**ADDENDUM NO. 1**

**PROJECT:** Special Education Alterations to  
Centennial High School  
Williamson County Schools  
J+B No. 2519  
WCS RFB #1408

**ARCHITECT:** Johnson + Bailey Architects, P.C.  
City Center, Suite 700  
100 East Vine Street  
Murfreesboro, TN. 37130

**LIFE SAFETY PLAN - FIRST FLOOR**

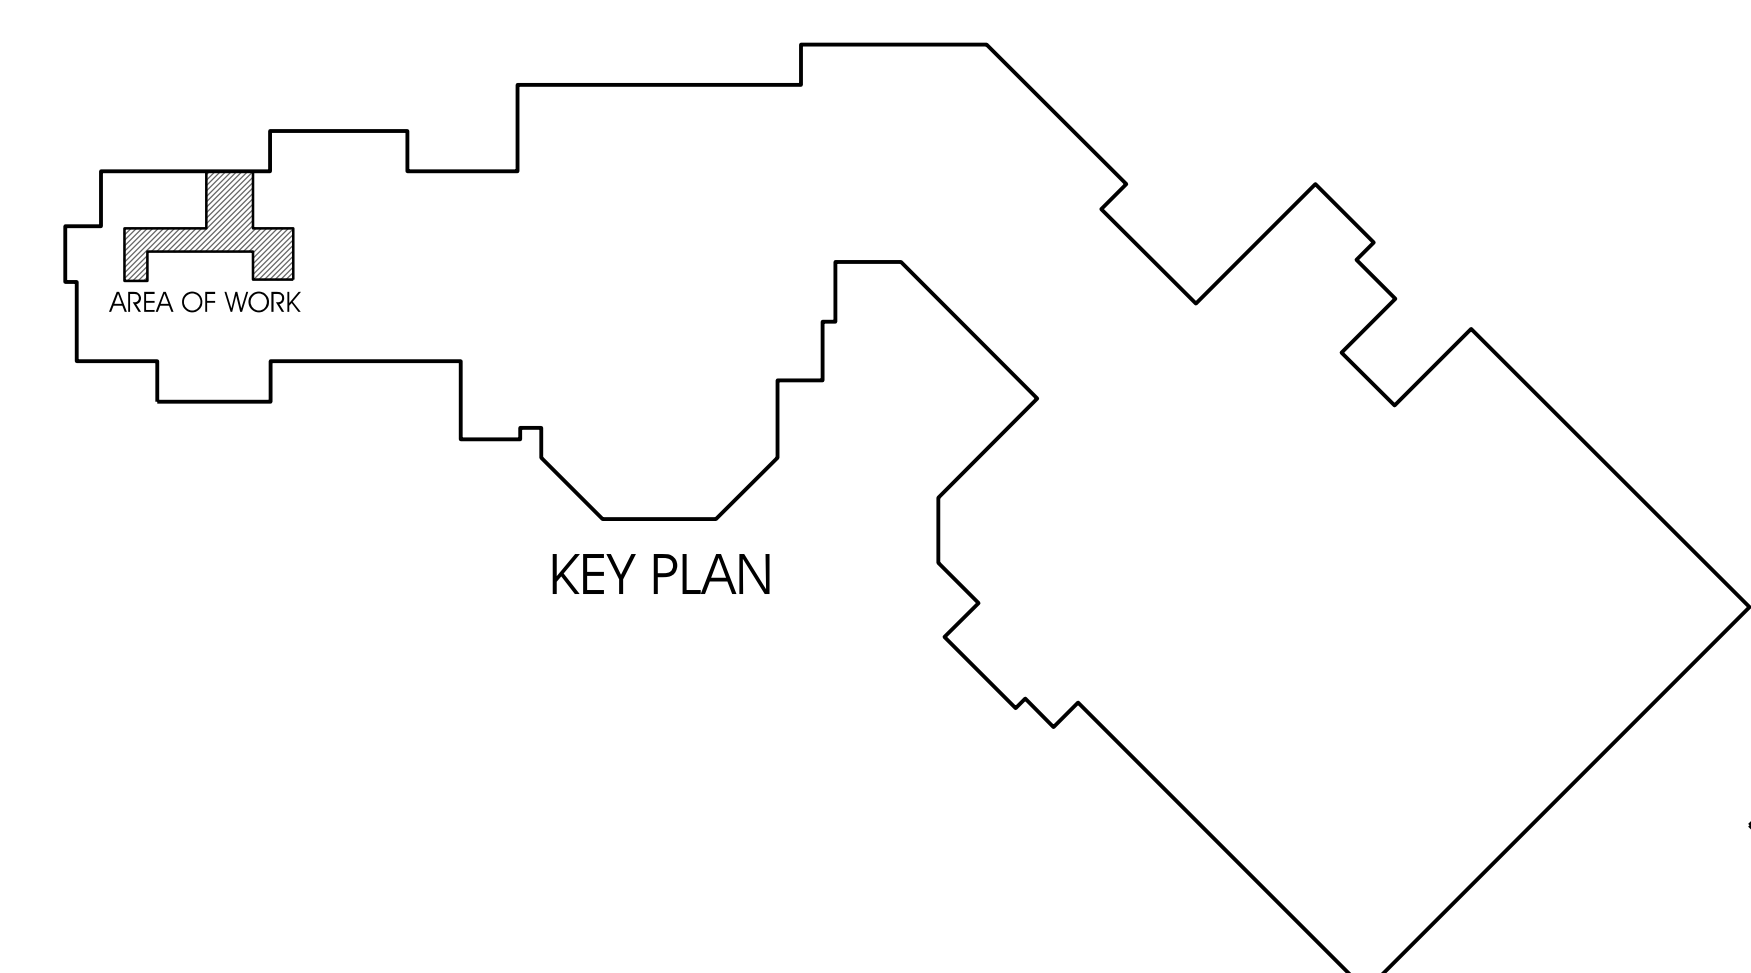
**REVISE:** Location of new calm room scope as shown on the attached revised drawing A1.2 dated 05/04/26.

**DEMOLITION REFLECTED CEILING PLAN - CLASSROOM D-11**

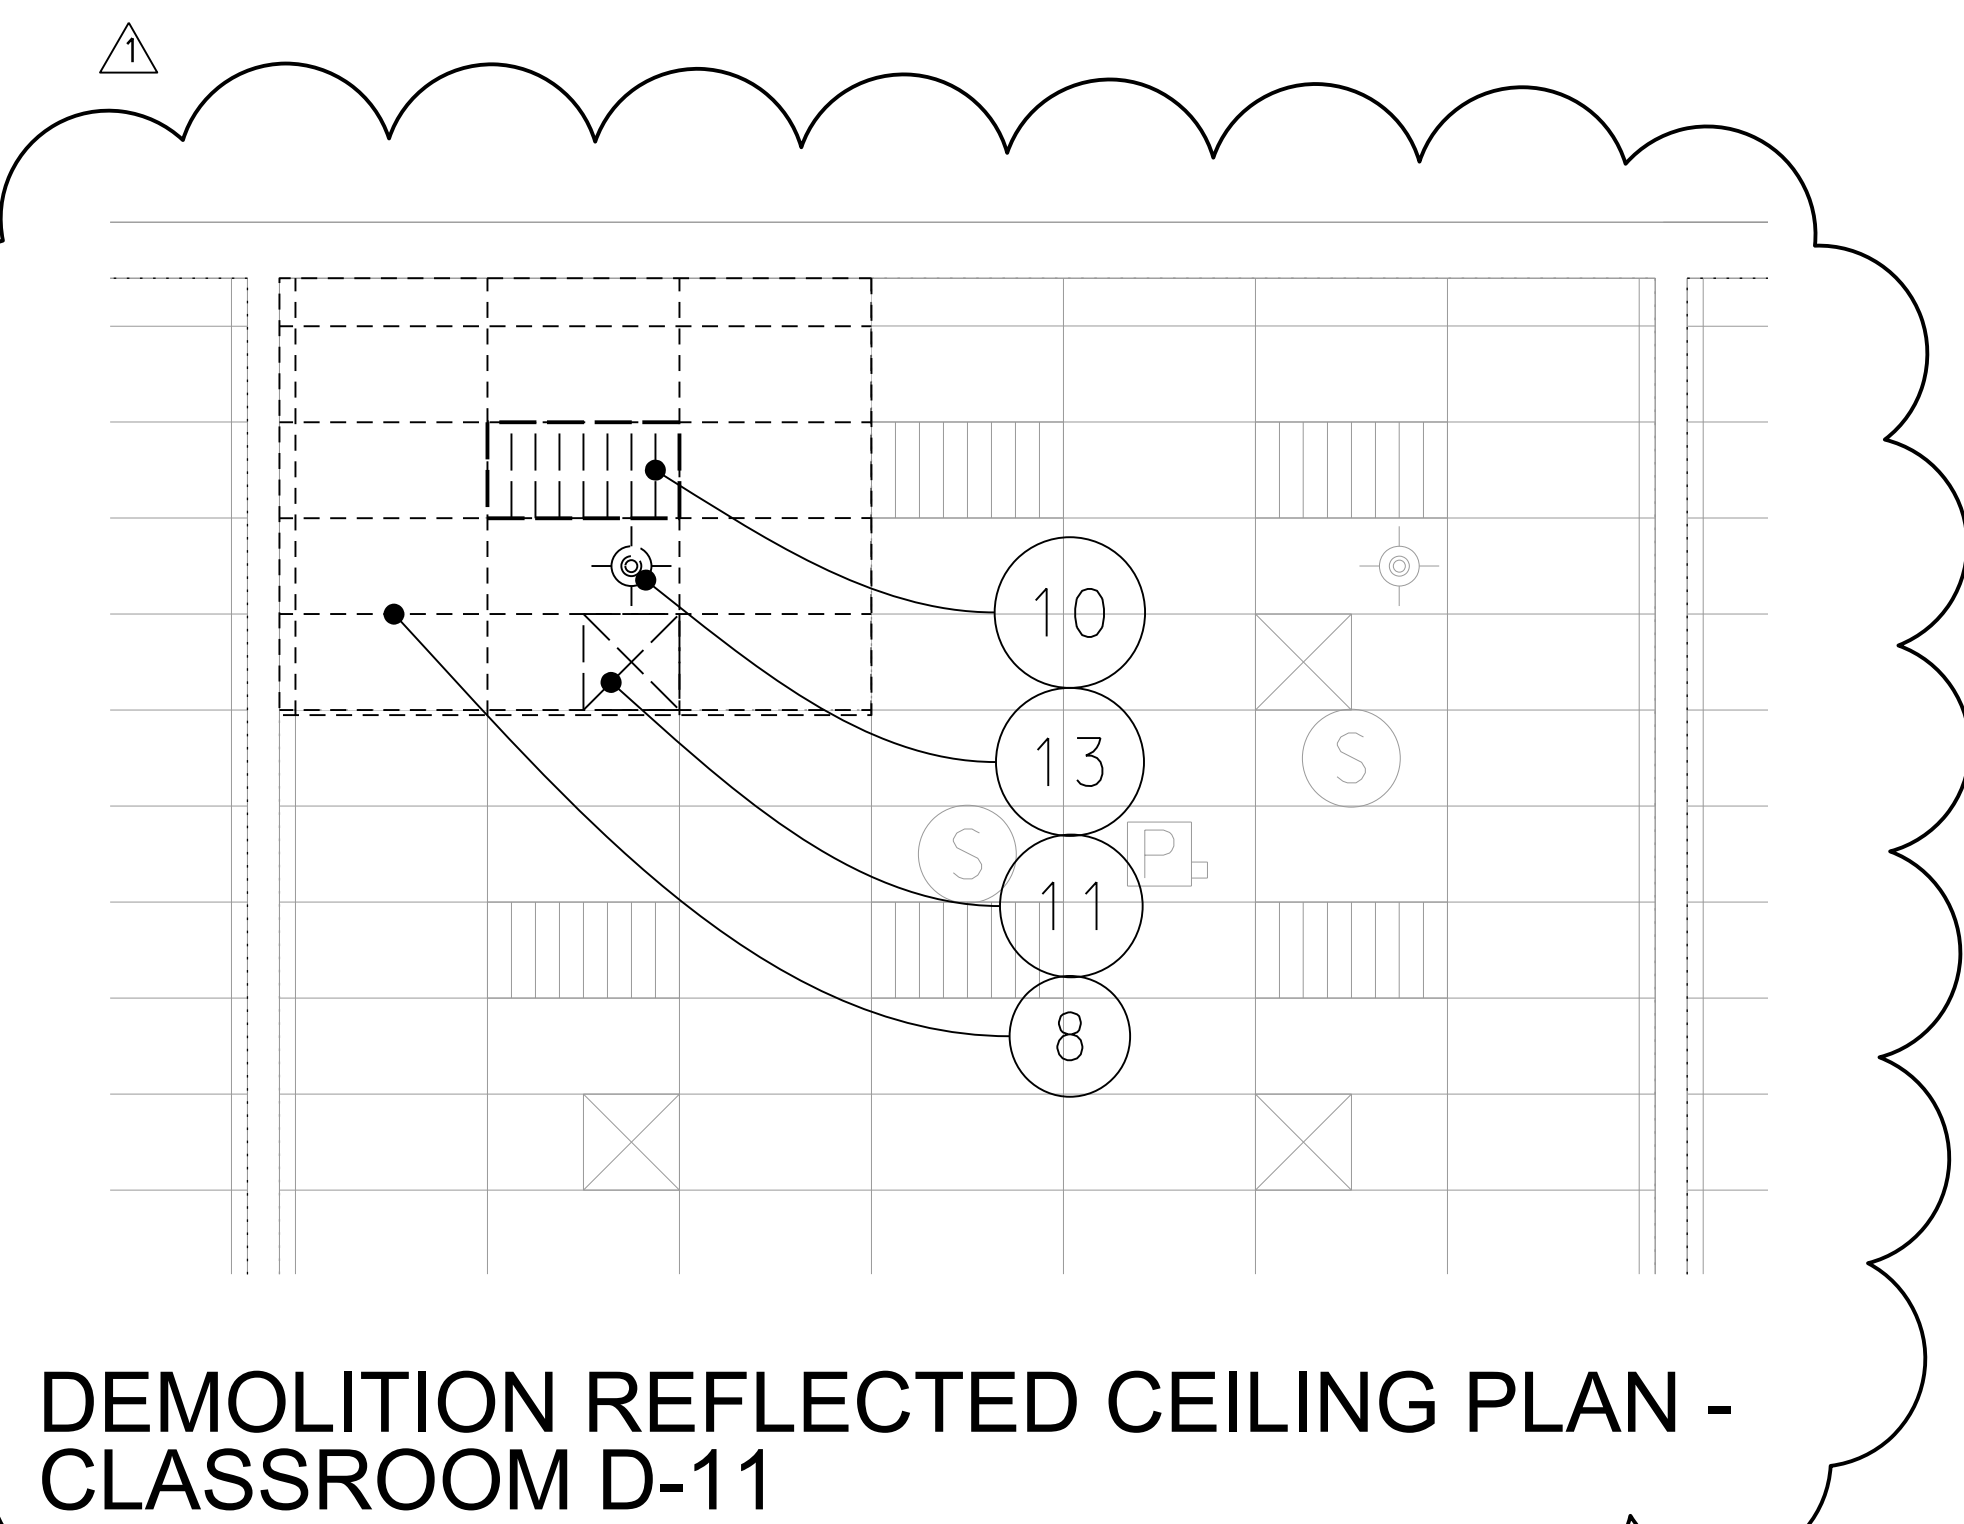
**REVISE:** Location of new calm room demolition scope as shown on the attached revised drawing A2.1 dated 05/04/26.

REFLECTED CEILING PLAN - NEW WORK - CLASSROOM D-11

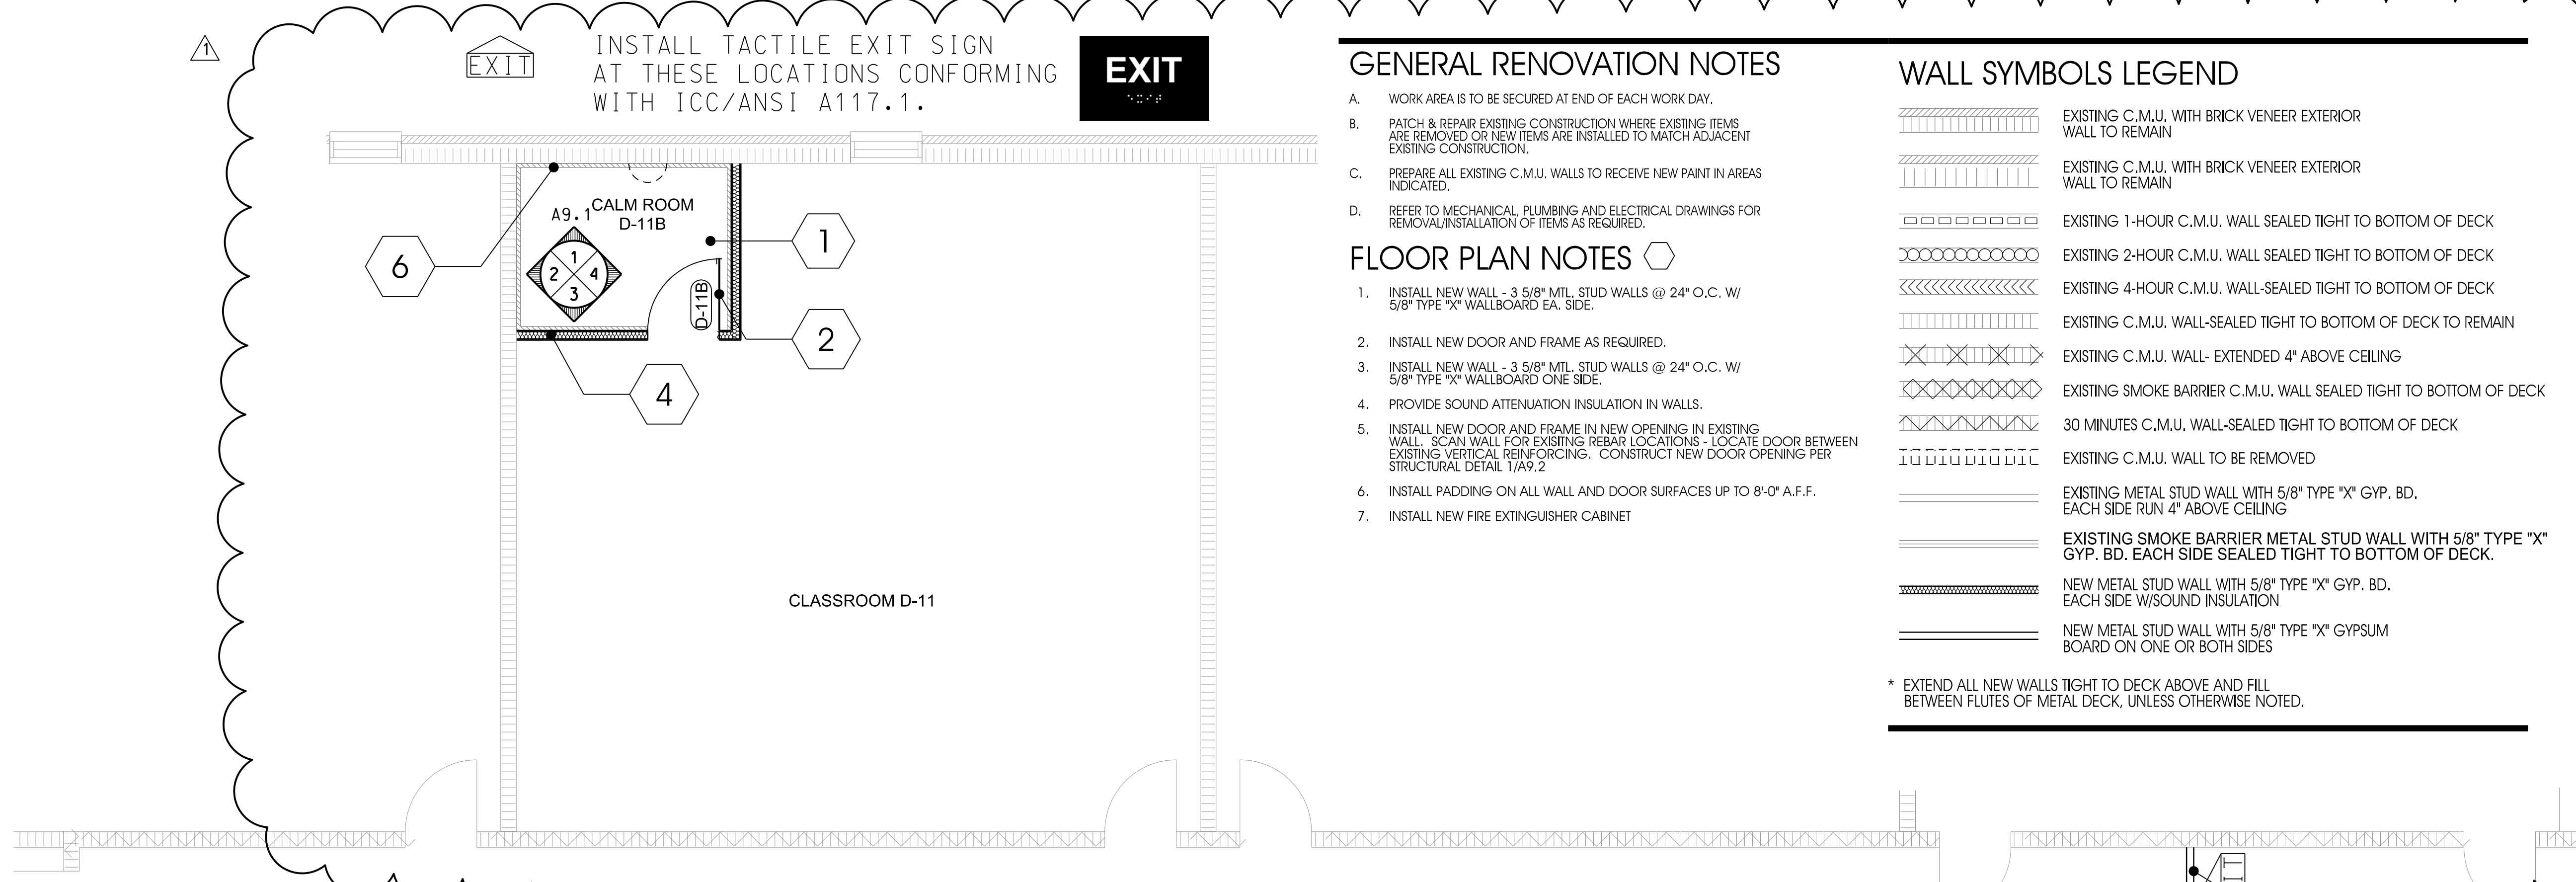
REVISE: Location of new calm room scope as shown on the attached revised drawing A2.2 dated 05/04/26.

LARGE SCALE FLOOR PLAN

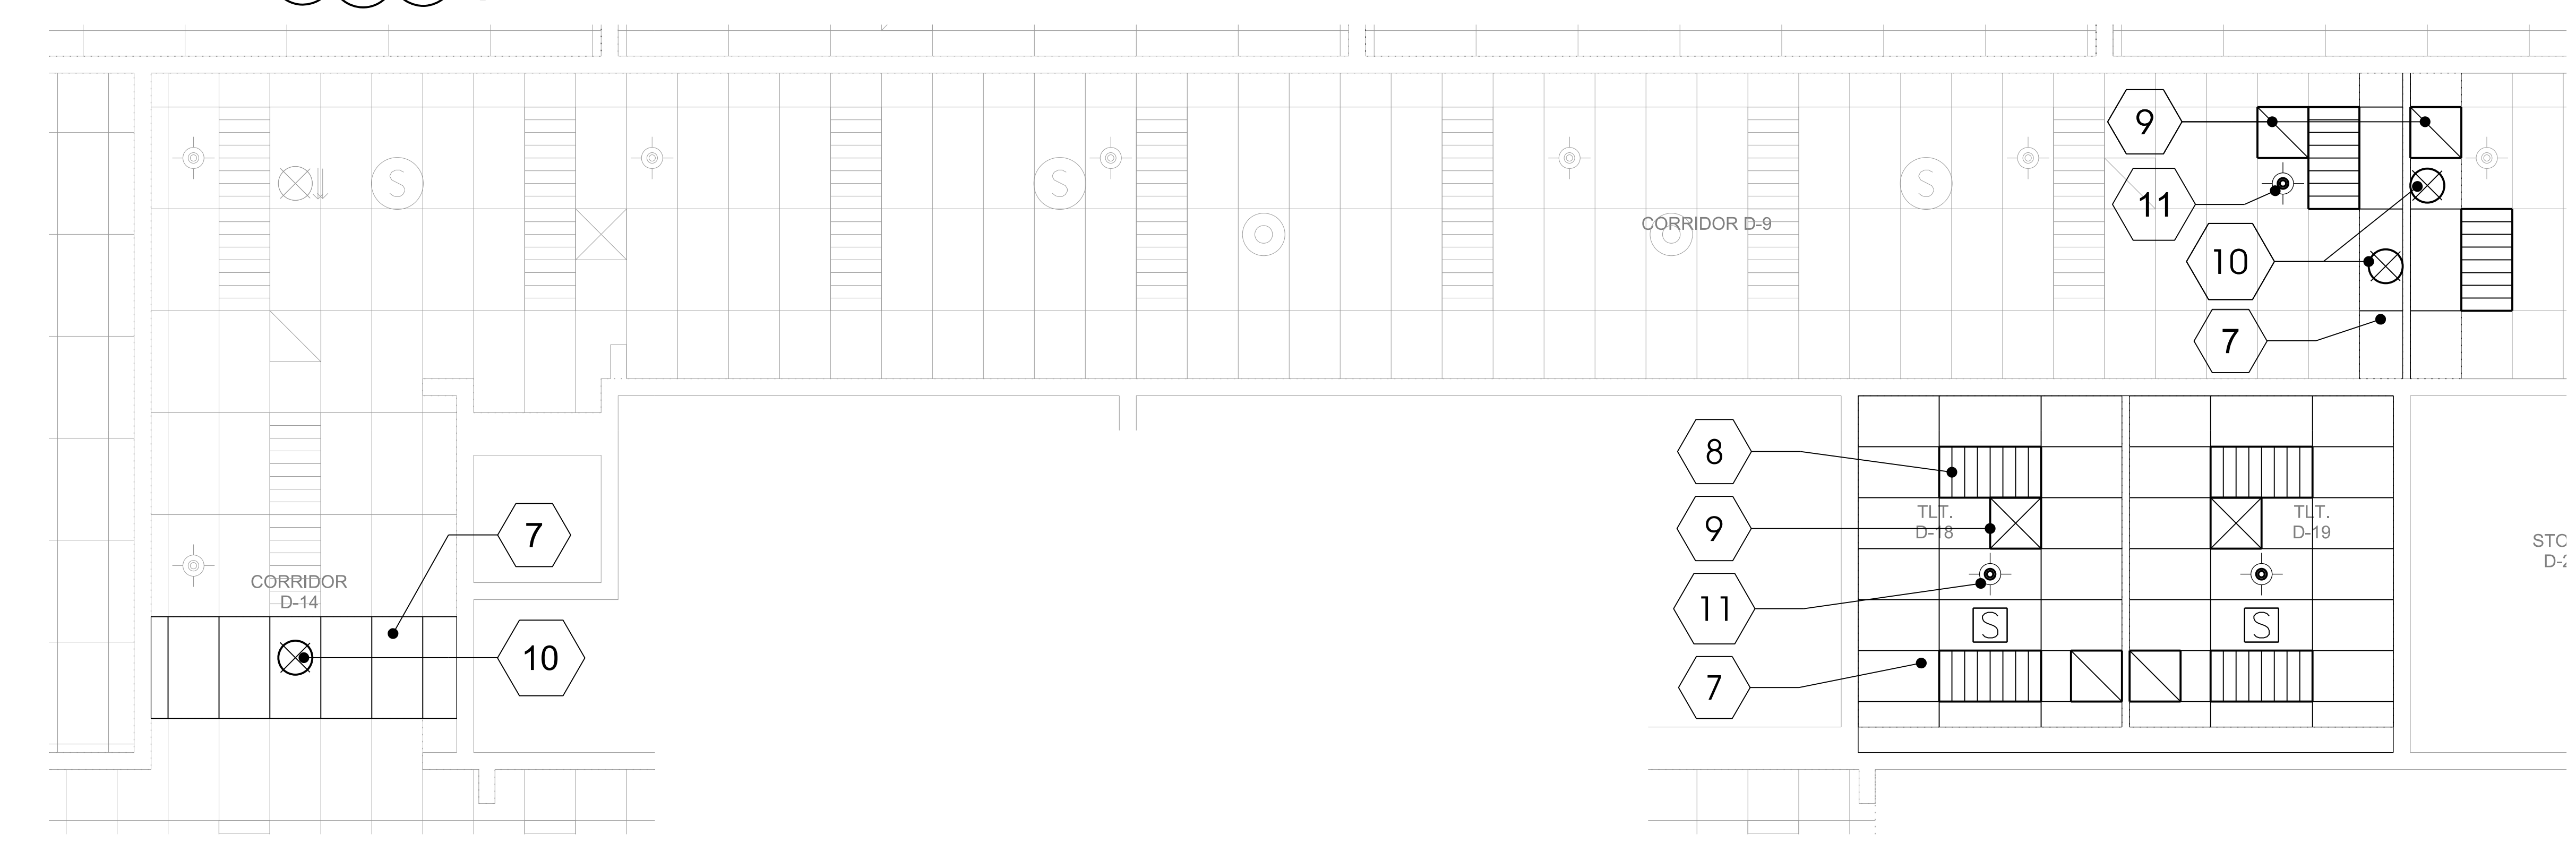
**REVISE:** Location of new calm room scope as shown on the attached revised drawing A2.2 dated 05/04/26.

9 TLT. D-19    10 TLT. D-19    11 TLT. D-19    12 TLT. D-19

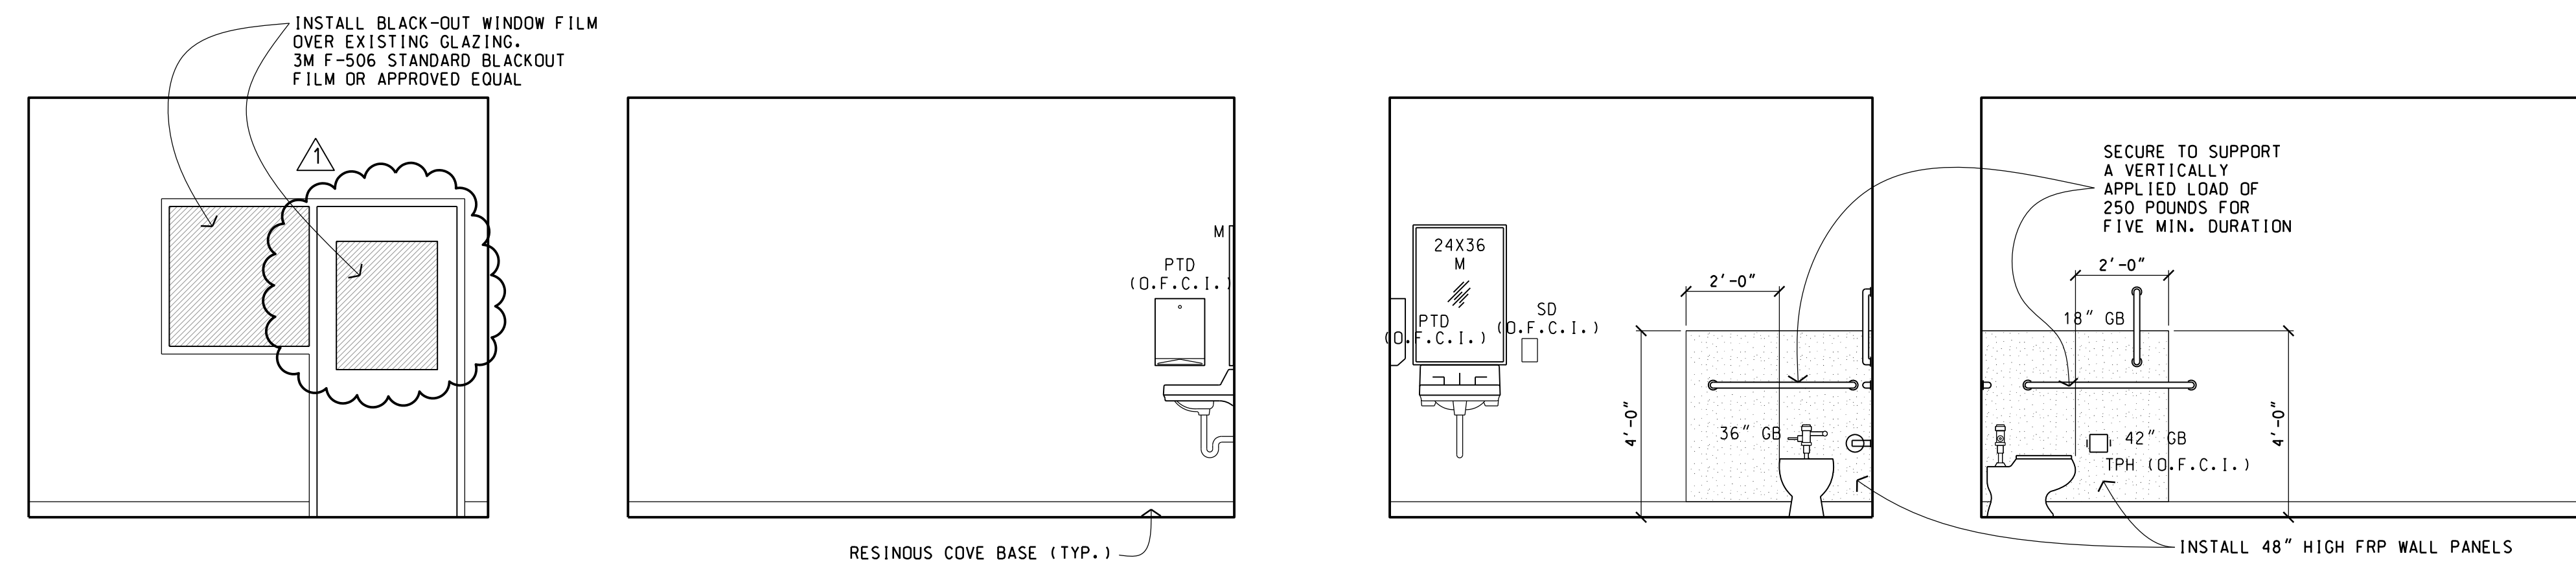
ADD: Glazing Blackout Film Scope to Door of Tit. D-19 as shown on the attached revised drawing A9.1 dated 05/04/26.
